BAR Meeting
October 15, 2014

ISSUE: Partial Demolition/Capsulation and Certificate of Appropriateness for Alterations

LOCATION: 115 Queen Street

BAR2014-00290 & BAR2014-00291

SOUTH ELEVATION - PROPOSED

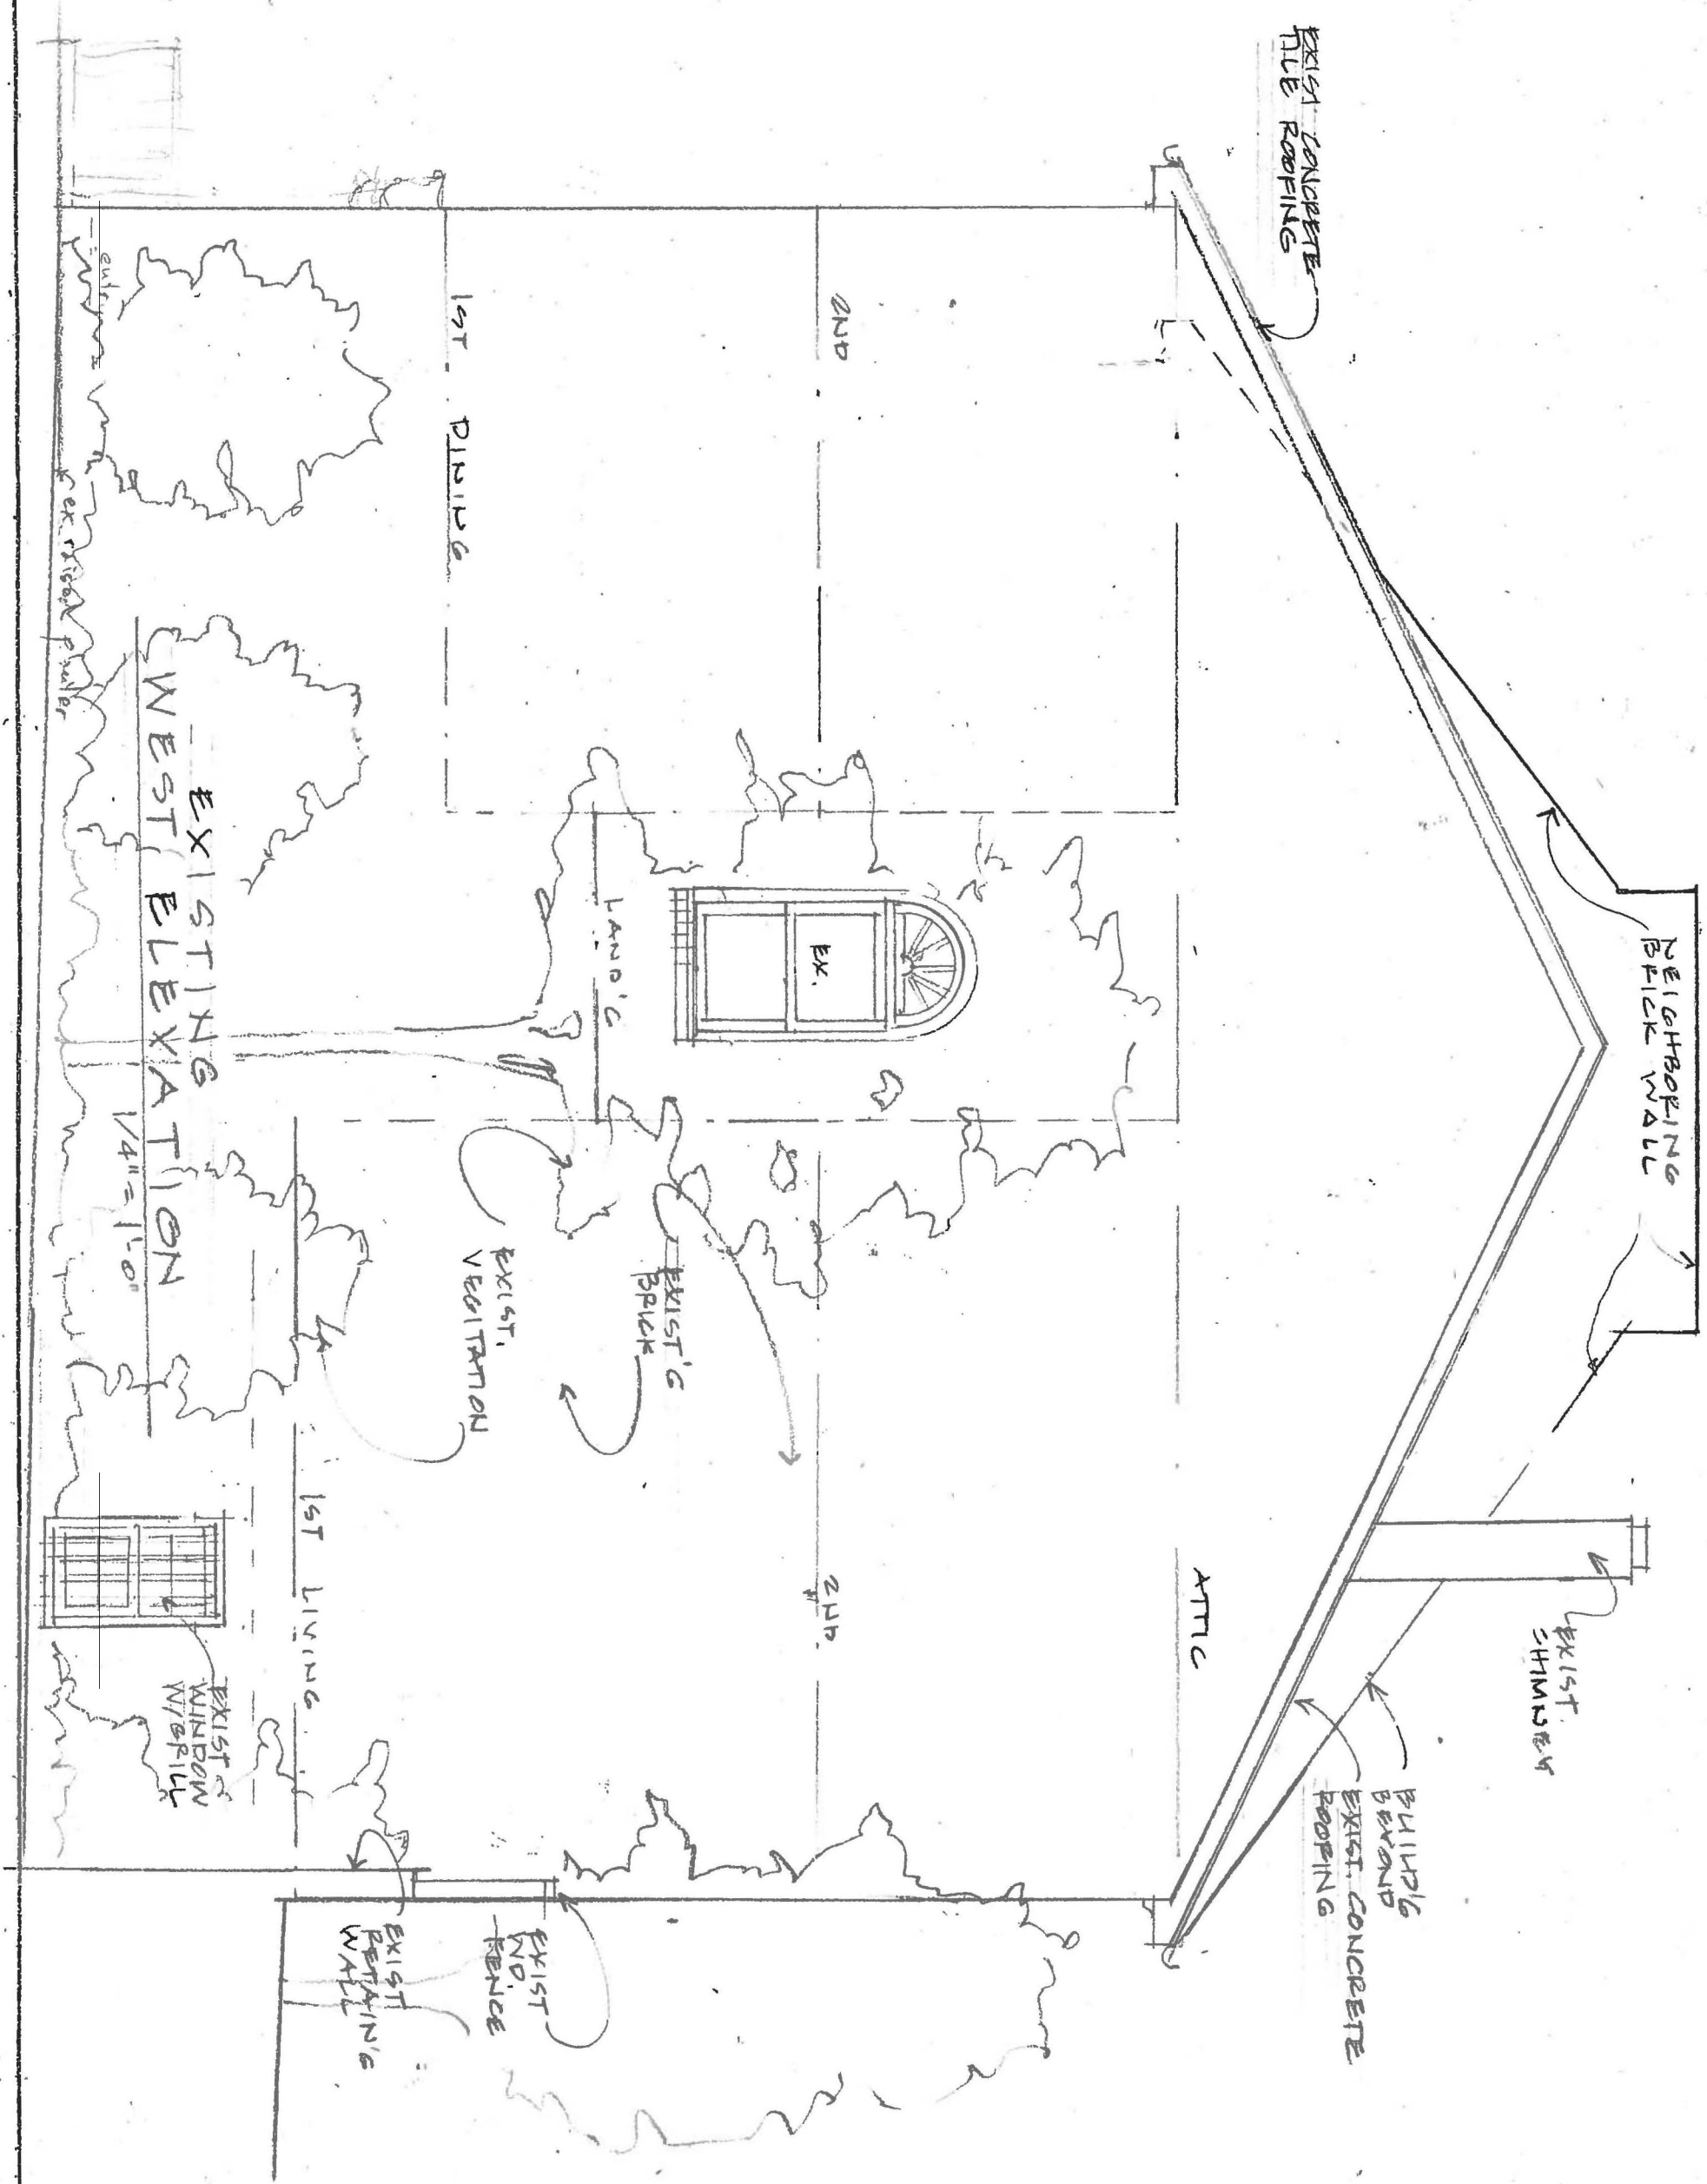
The proposed replacement garage door is very similar to the existing and could be approved administratively by staff under the *BAR Minor Architectural Elements Policy*. The proposed cornice above the garage, however, is an alteration that requires Board approval. Staff supports the cornice, as it matches the design of the existing door hood. Staff recommends a wood or high quality, paintable, millable and solid-thru-the-core synthetic material, as the Board has previously stated that high quality modern materials are acceptable on later structures.

1. That the applicant work with staff to accurately determine the existing roof material, with staff approval of the replacement in compliance with the *BAR Roof Policy*;
2. That the skylight flashing matches the color of the roofing;
3. That the skylights have integral shades;
4. That the windows comply with the *BAR Window Policy* Performance Specifications, with final approval by staff during building permit review and;
5. That the cornice above the garage be either wood or a high-quality, paintable, solid-through-the-core composite.

Fixed skylights

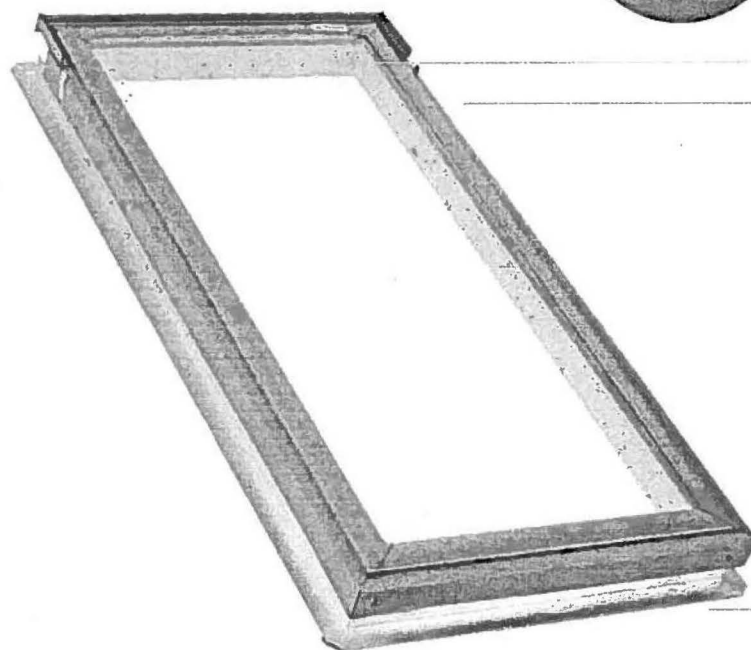
The *Design Guidelines* state that skylights should be located on the least visible location of the roof and should have integral shades to reduce the seepage of light at nighttime. Further, the guidelines recommend that the flashing should match the color of the roof covering. Staff finds that the location and low-profile of the skylights is appropriate, with the condition that the flashing matches the color of the roofing and the applicant install integral shades.

SHINGLE COLOR TO BE
OYSTER GRAY

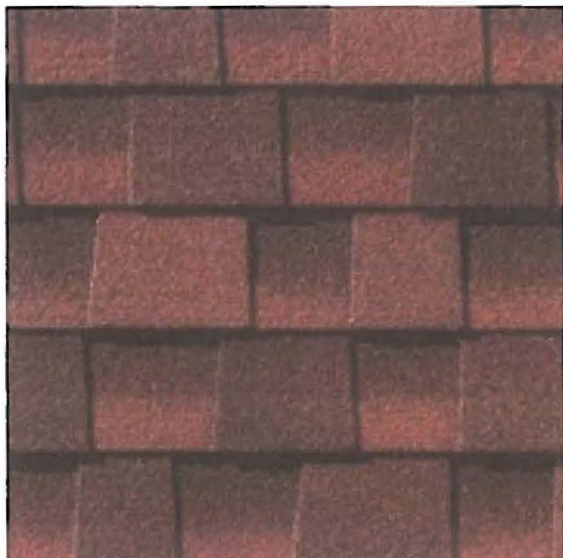
As a general policy, the Board discourages the use of asphalt or fiberglass shingles for roofing material, although the *Design Guidelines* state that fiberglass and asphalt shingles are appropriate on late 20th century structures. The *BAR Roof Policy* permits architectural grade composition roofing when it replaces original composition roofing, such as fancy-cut asphalt shingles used in the early 20th century. The policy also permits architectural grade composition roofing as a replacement for a Supra-Slate type simulated slate or other cement-asbestos roofing tile products on buildings constructed after 1975 and not located on the George Washington Memorial Parkway. The policy does not, however, permit replacement of authentic slate with composition shingles.

There is some question as to whether or not the existing roof material on the subject property is authentic slate or a composite tile, as both were used in this development. Therefore staff recommends that the applicant work with staff to determine the actual material and that the roof be replaced in accordance with the *BAR Roof Policy*, meaning that if the roof material is a

cement-asbestos product, architectural grade composition shingles can be used. However, if the roof is true slate, the applicant must replace with authentic slate in a matching color and pattern.
